Conceptual Review Agenda

Time	Project Name	Applicant Info	Project Description	Planner
9:30	500 Riverside Ave - Solar Energy Facility CDR140018	Norm Weaver 970-416-2312 nweaver@fcgov.com	This is a request to construct a solar energy collection facility at 500 Riverside Avenue (Parcel # 97124-00-907). The facility would consist of ground-mounted solar panels generating up to 600 kilowatts for Fort Collins Utilities. The site is located in the River Downtown Redevelopment (R-D-R) Zone District.	Ryan Mounce

CONCEPTUAL REVIEW:
APPLICATION

Re: 500 Riverside Ave - Solar Energy Facility

Subject Area Flood Plain Map

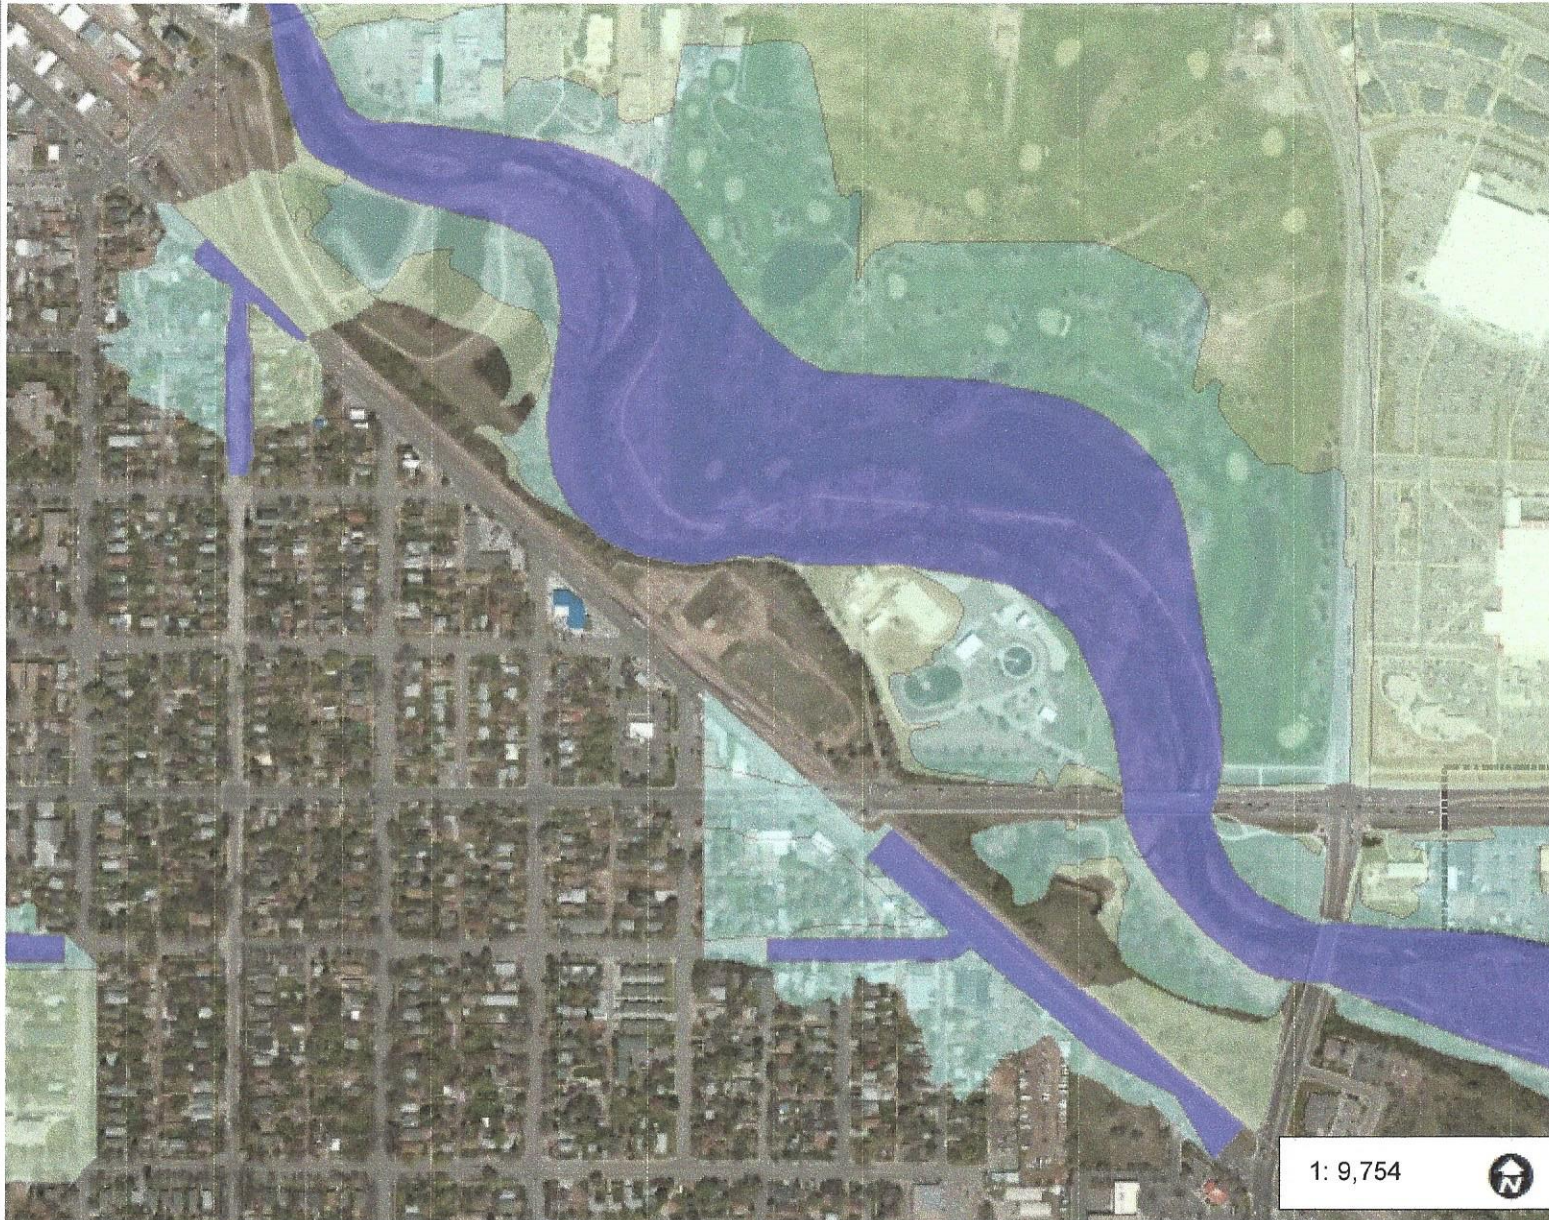
1. Floodplain Comments:
A small portion of this lot is located in the FEMA-regulatory Poudre River 100-year floodplain, and the proposed project must satisfy all safety requirements of Chapter 10 of City Code. A FEMA Flood Risk Map is attached.

2. The majority of this property is elevated 30 - 40 feet above the Poudre River, and is not located in any portion of the floodplain. The proposal submitted for this review indicates that all development will take place on the elevated part of the lot and not in the floodplain. As long as all development is confined to that elevated portion of the lot that is not in the floodplain, there will be no floodplain construction standards for development.
